ON-SITE SEWAGE DISPOSAL SYSTEM HOWARD COUNTY HEALTH DEPARTMENT BUREAU OF ENVIRONMENTAL HEALTH

SUBDIVISION: Clarks Meadow LOT NUMBER: 3

ADDRESS: 14413 Meadow Mill Way PROPERTY OWNER: Steve Poore/ L Lenderman

CLARKS MEADOW PLOT PLAN LOT 3

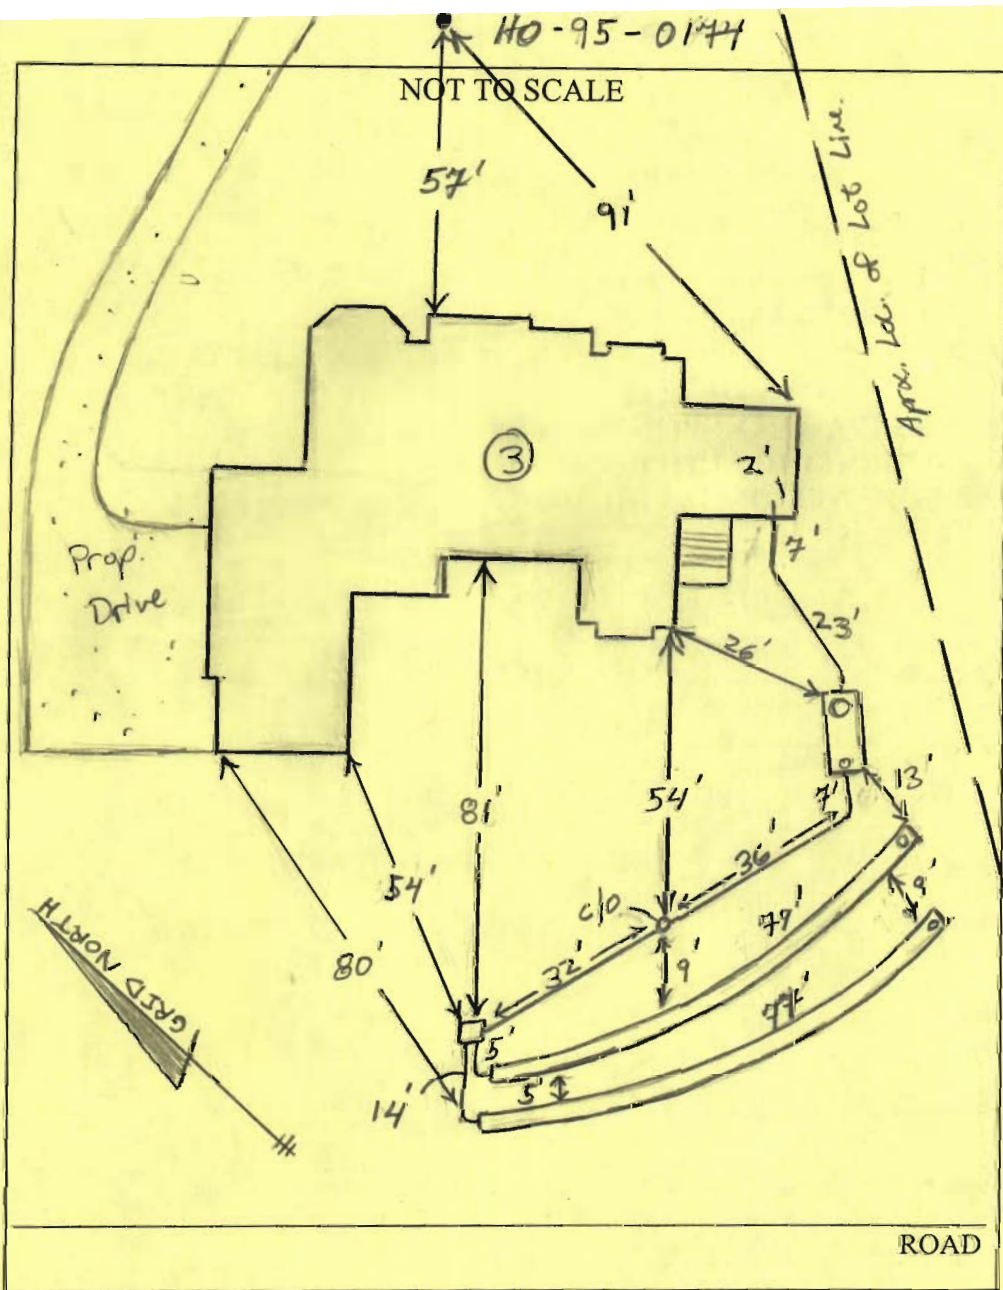
*Inlet 3.5'
bottom 6'*
*2' of SW. for 3' wet
trench is .62*
$$\frac{150 (.4)}{0.8} \div 3 = 250 (.62) = 155$$

*2 x 80'
trenches
OK.*

PRE-CONSTRUCTION 8/17/07 Arnold wife. Alan not here. Judy was there for layout. Told her for Alan to install 2

INSTALLATION 80' trenches on contour running either side of SDA. D box to be set per plan w/ c/o. changed sys specs to accommodate 2' of sw. Call health dept if not understood (P)

8/22/07 System complete. Contractor used resin paper on trenches instead of geotextile fabric. Told contractor OK for this use but next time will not be used. (OK) to backfill. (P)

WALL CHECK
CLARKS MEADOW
LOTS 1 THRU 26
PLAT No. 18483
 LOT No. 3

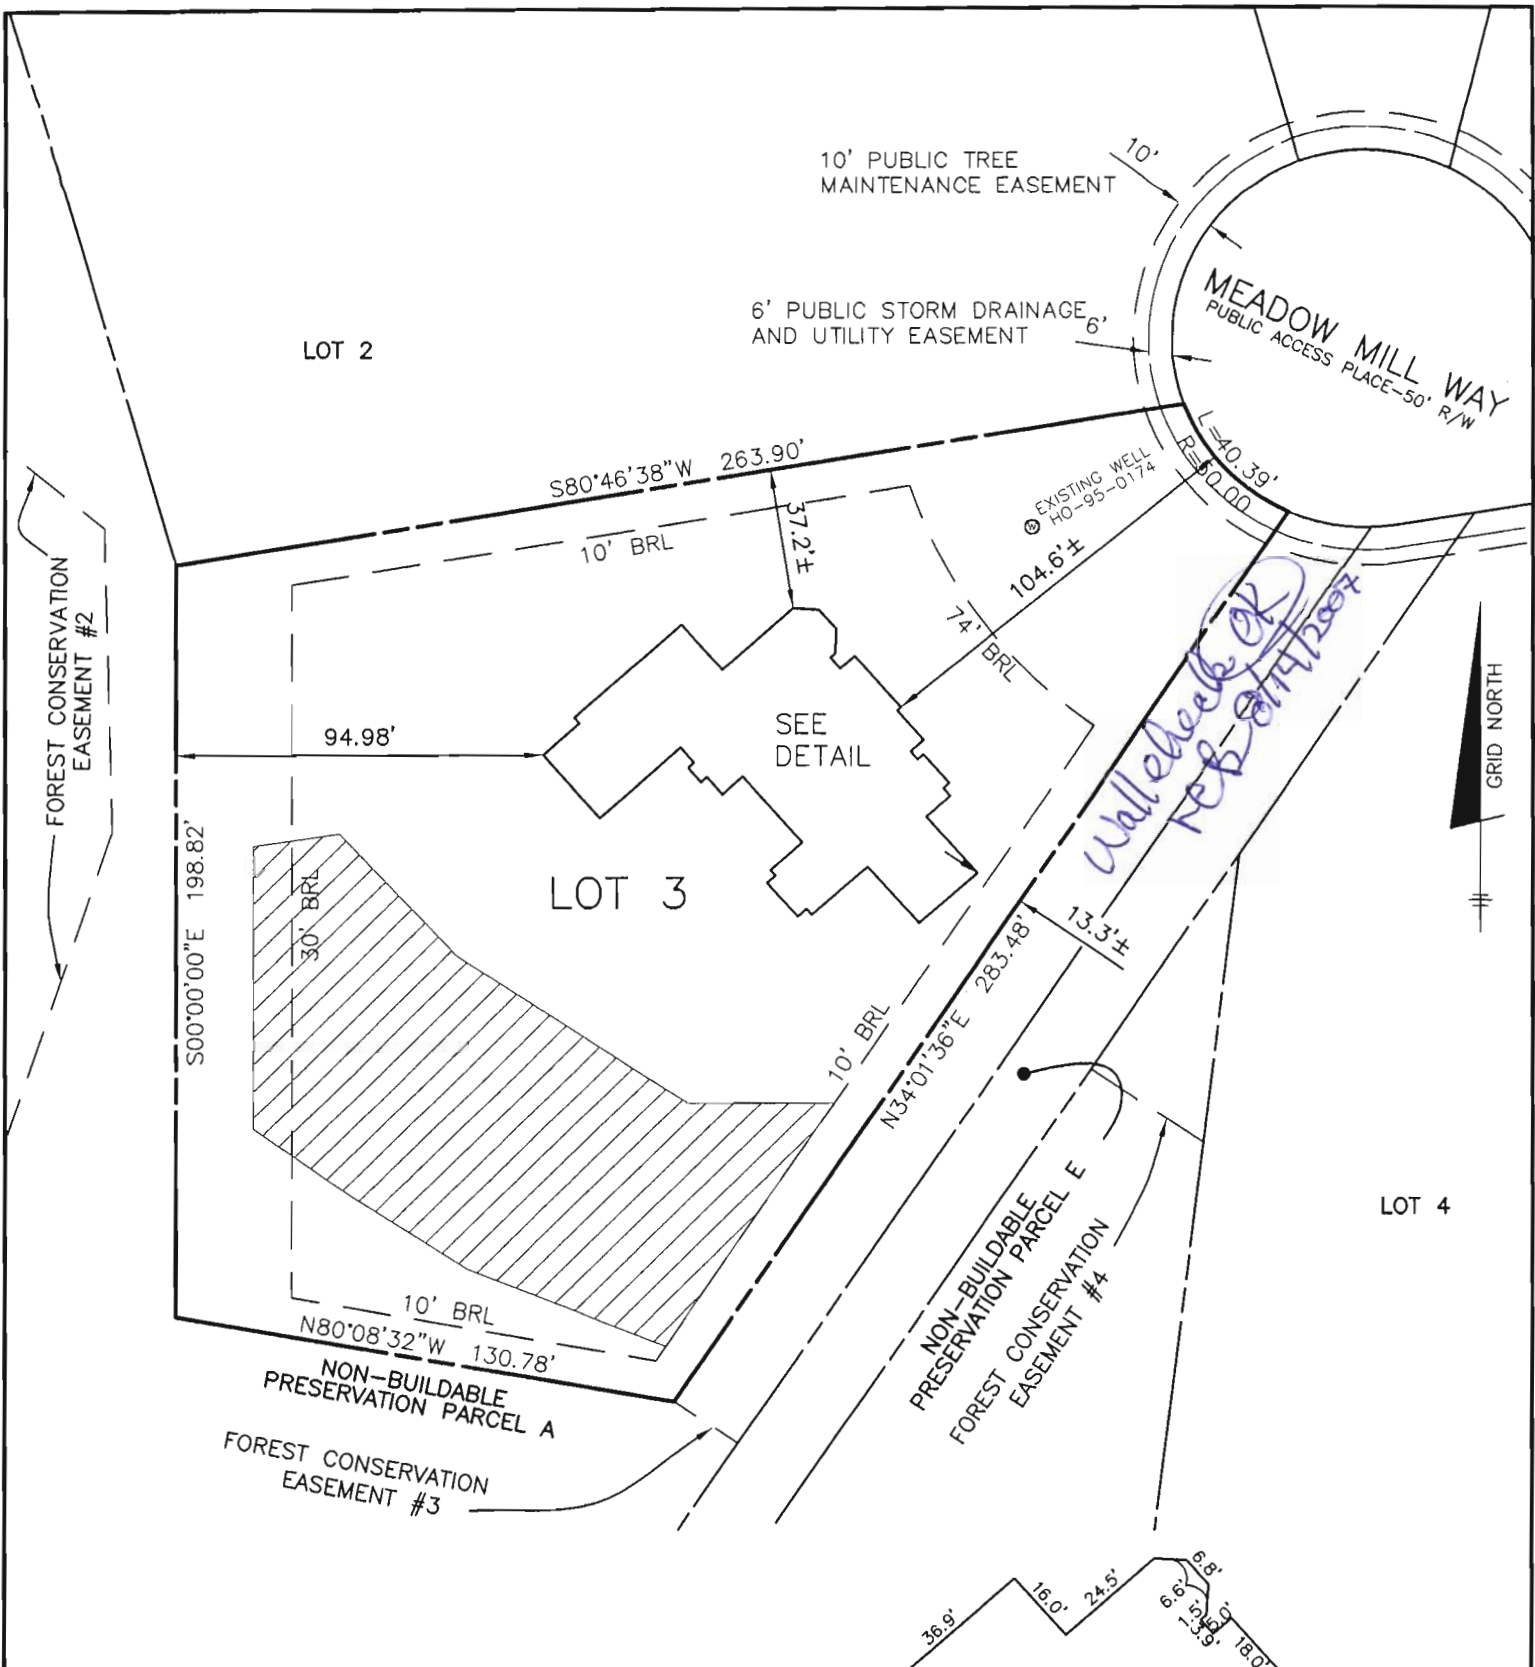
*Wallcheck OK
Reb 01/14/2007*
